WELL API NO. 30-025-45029
5. Indicate Type of Lease STATE <input type="checkbox"/> FEE <input checked="" type="checkbox"/>
6. State Oil & Gas Lease No.
7. Lease Name or Unit Agreement Name TREY SWD
8. Well Number 1
9. OGRID Number 161968
10. Pool name or Wildcat [97869] SWD; DEVONIAN-SILURIAN

NOTICE OF INTENTION TO:		SUBSEQUENT REPORT OF:	
PERFORM REMEDIAL WORK <input type="checkbox"/>	PLUG AND ABANDON <input type="checkbox"/>	REMEDIAL WORK <input type="checkbox"/>	ALTERING CASING <input type="checkbox"/>
TEMPORARILY ABANDON <input type="checkbox"/>	CHANGE PLANS <input checked="" type="checkbox"/>	COMMENCE DRILLING OPNS. <input type="checkbox"/>	P AND A <input type="checkbox"/>
PULL OR ALTER CASING <input type="checkbox"/>	MULTIPLE COMPL <input type="checkbox"/>	CASING/CEMENT JOB <input type="checkbox"/>	
DOWNHOLE COMMINGLE <input type="checkbox"/>			
CLOSED-LOOP SYSTEM <input type="checkbox"/>			
OTHER: Change plans/tubing size <input checked="" type="checkbox"/>		OTHER: <input type="checkbox"/>

Mesquite SWD, Inc.
Trey SWD No. 1: Proposed Wellbore Schematic
200' FNL & 200' FEL (Unit A)
Section 21, T-23S, R-32E, NMPM, Lea County, NM

Exhibit No. 3
Proposed Wellbore Configuration

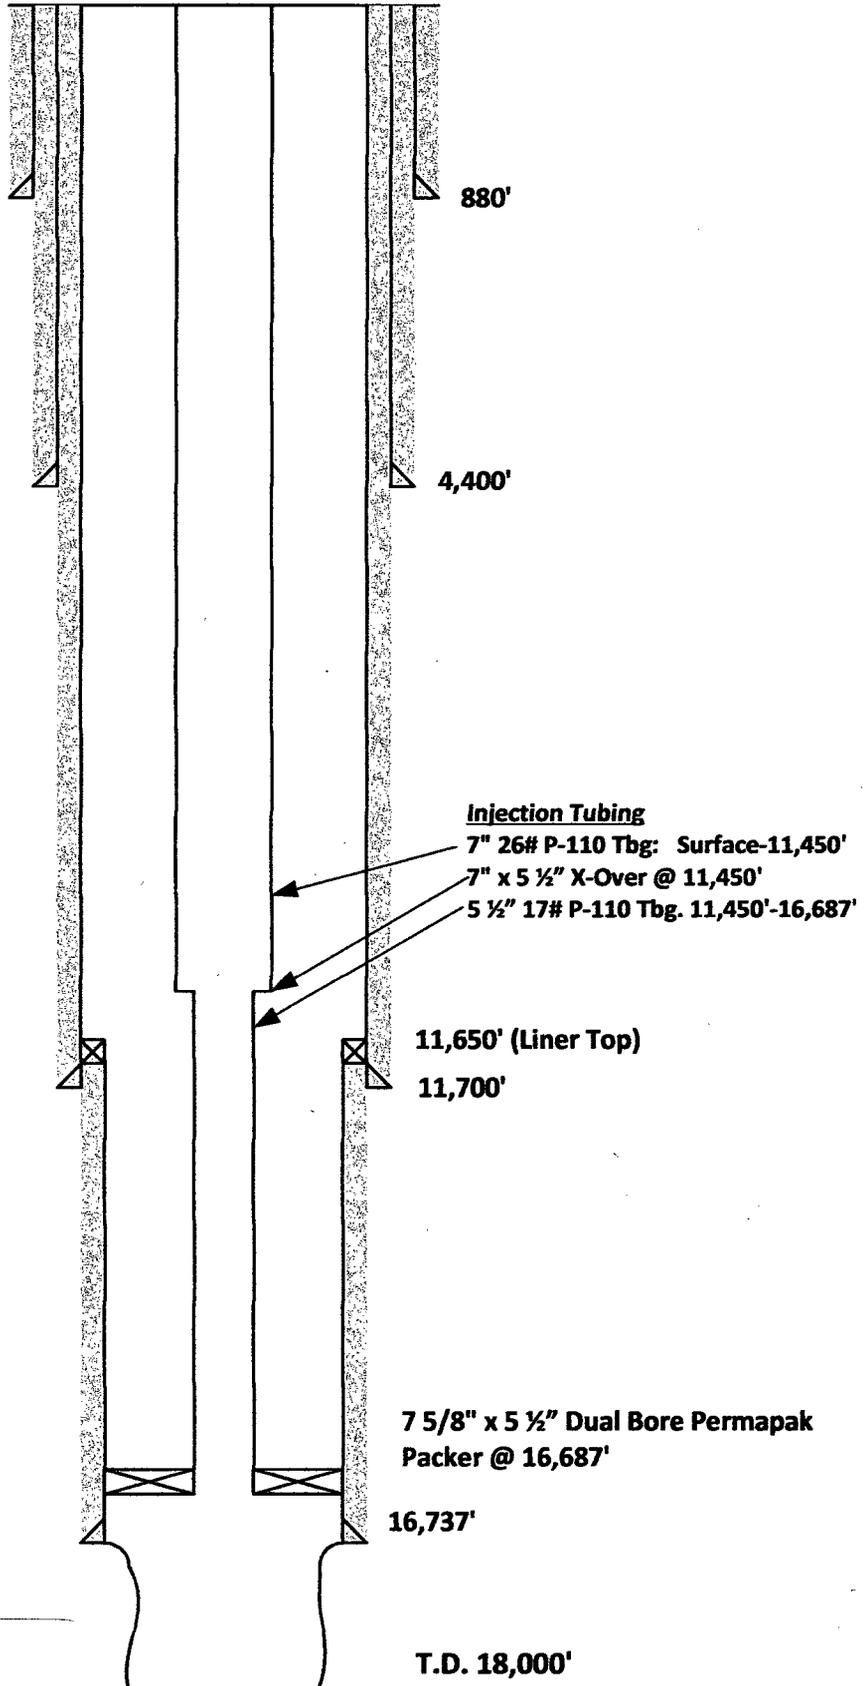
SWD-1699 authorizes the use of 5 1/2" or smaller tubing inside the surface and intermediate casing and 4 1/2" or smaller tubing inside the liner. Mesquite SWD, Inc. respectfully requests permission to run 7" tubing or smaller inside the surface and intermediate casing and 5 1/2" tubing or smaller inside the liner.
